PCN #191
Notification Date:
June 19, 2020

Product / Process Change Notice

Chip process CP771, P-channel MOSFETs, wafers and bare die.

Figure 1: CP771 Chip Geometry (Discontinued)

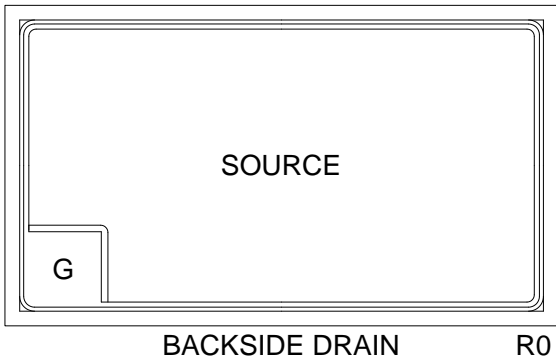
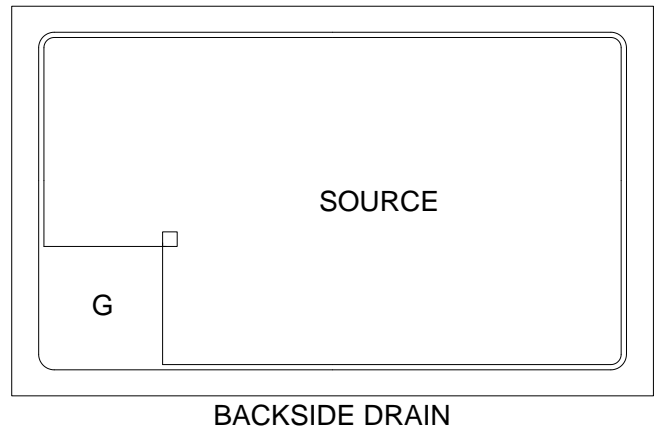
The CP771 wafer process has been discontinued and is being replaced with the CP805 wafer process. See Figures 1 and 2 for details.

Wafer Diameter: 8 inch
Die Size: 55 x 32 mils
Die Thickness: 7.5 mils
Bond Pad Size (Gate): 7.3 x 7.3 mils
Bond Pad Size (Source): 50 x 25 mils
Topside Metal: Al (40,000Å)
Backside Metal: Ti/Ni/Ag (1,000Å/3,000Å/10,000Å)

Wafer Diameter: 8 inch
Die Size: 63.8 X 38.9 mils
Die Thickness: 5.5 mils
Bond Pad Size (Gate): 7.1 x 7.1 mils
Bond Pad Size (Source): 60.4 x 35.6 mils
Topside Metal: Al-Cu (40,000Å)
Backside Metal: Ti/Ni/Ag (1,000Å/3,000Å/10,000Å)
